Central Valley Regional Water Quality Control Board
22/23 April 2021 Board Meeting

Response to Comments
for the
Sacramento Regional County Sanitation District
Sacramento Regional Wastewater Treatment Plant
Tentative Waste Discharge Requirements

Figure F-5. Effluent Bis(2-ethylhexyl) Phthalate Monitoring Results

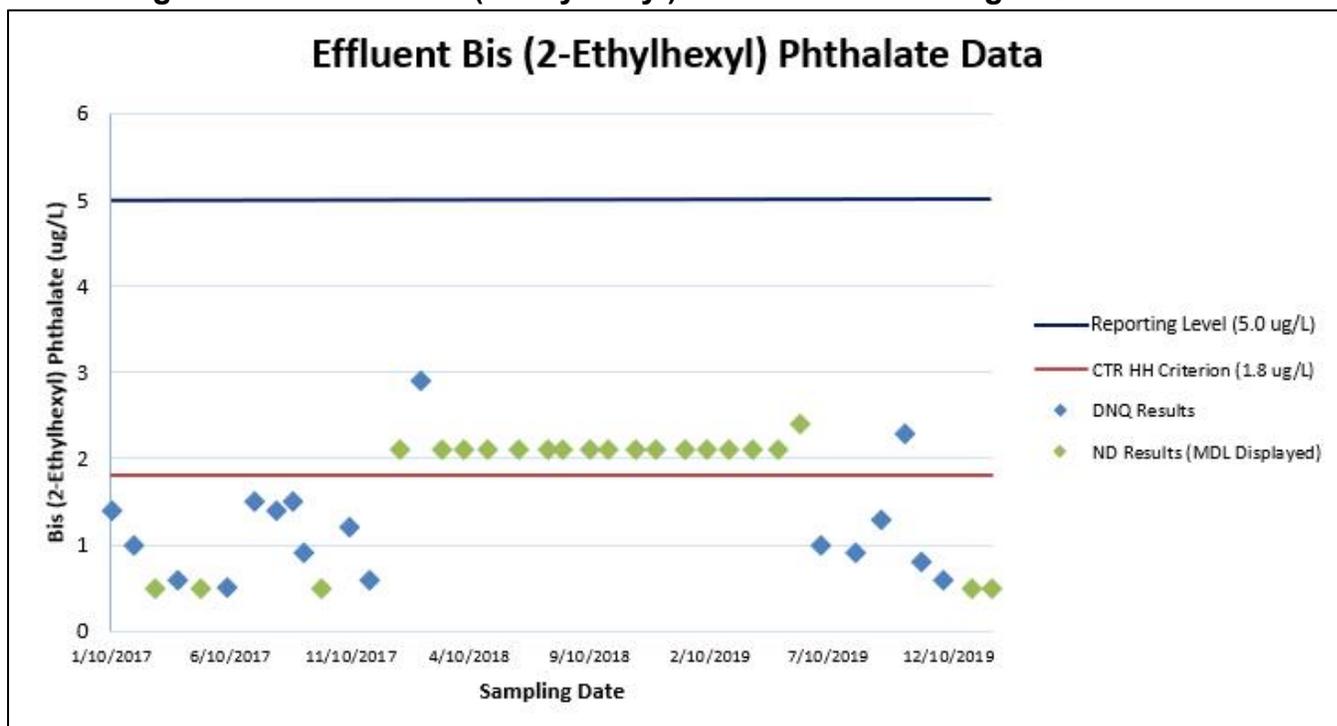
Discharger Comment 1: Reasonable Potential Analysis for Bis(2-ethylhexyl) phthalate.

The Discharger contends that the decision to find the January 2017 through February 2020 dataset insufficient and instead rely on the dataset from the previous permit renewal (January 2012 – December 2014) is not a proper application of the State's *Policy for Implementation of Toxics for Inland Surface Waters, Enclosed Bays, and Estuaries of California* (SIP), that there is no reasonable potential for bis(2-ethylhexyl) phthalate, and effluent limitations for bis(2-ethylhexyl) phthalate should be removed from the proposed Order.

The Discharger noted that within the monitoring data for bis(2-ethylhexyl) phthalate submitted with its Report of Waste Discharge (ROWD), which included 36 grab samples of effluent collected from January 2017 through February 2020, all results were either not detected or were detected but not quantified (DNQ) data. The Tentative Order states there were multiple instances in which the laboratory method detection limit (MDL) used was greater than the applicable water quality criterion from the California Toxics Rule (CTR). The Discharger states that nothing in section

RESPONSE: Central Valley Water Board staff concurs in part. Staff concurs that the effluent dataset from the previous permit renewal (January 2012 – December 2014) should not be used for the proposed Order to support a finding of reasonable potential for bis(2-ethylhexyl) phthalate to cause or contribute to an exceedance of water quality objectives in the receiving water. However, staff do not concur that the bis(2-ethylhexyl) phthalate effluent limitations should be removed. The January 2017 - February 2020 data is insufficient to conduct a reasonable potential analysis and does not justify less stringent effluent limitations for bis(2-ethylhexyl) phthalate in the proposed Order under the federal anti-backsliding regulations.

The monitoring data for bis(2-ethylhexyl) phthalate submitted by the Discharger with its ROWD is insufficient to conduct a reasonable potential analysis and support a finding of no reasonable potential. The laboratory analyses used a Reporting Level of 5.0 µg/L, which exceeds the CTR criterion of 1.8 µg/L for bis(2-ethylhexyl) phthalate. 17 of the 36 samples were DNQ, which means the results lie between the method detection limit and the reporting level of 5.0 µg/L. DNQ data is not reliable and should not be used to conduct the RPA. However, the data indicates the discharge may be exceeding the CTR criterion. Therefore, while staff concur the January 2017 - February 2020 effluent data set does not demonstrate the discharge has reasonable potential, it is also not appropriate to make a finding of no reasonable potential based on the data. The SIP Section 1.2 allows the Regional Board discretion to find that data are insufficient to conduct a reasonable potential analysis. There were multiple detections of bis(2-ethylhexyl) phthalate in the effluent and the reporting levels were insufficient to quantify the data to verify that the results

The Fact Sheet in the proposed Order has been revised to clarify the reasonable potential analysis and need to maintain the existing effluent limitations for bis(2-ethylhexyl) phthalate per the anti-backsliding requirements as shown below. The discussion regarding the reasonable potential analysis for bis(2-ethylhexyl) phthalate has also been relocated from Section IV.C.3.d of the Fact Sheet for Constituents with Reasonable Potential to Section IV.C.3.c for Constituents with No Data or Insufficient Data.

- (a) **WQO.** The CTR includes a criterion of 1.8 µg/L for bis(2-ethylhexyl) phthalate for the protection of human health for waters from which both water and organisms are consumed.
- (b) **RPA Results.** As shown in the figure below, all effluent bis(2-ethylhexyl) phthalate samples collected from January 2017 through February 2020 were either non-detect or detected but not quantified (DNQ). Bis(2-ethylhexyl) phthalate was not detected in the upstream receiving water, with a method detection limit of either 2.1 µg/L or 0.5 µg/L, based on eight samples collected from January 2017 through February 2020. Figure F-5, below, shows effluent bis(2-ethylhexyl) phthalate sample results. Non-detect values are represented by the applicable method detection limit and the DNQ results are estimated values.
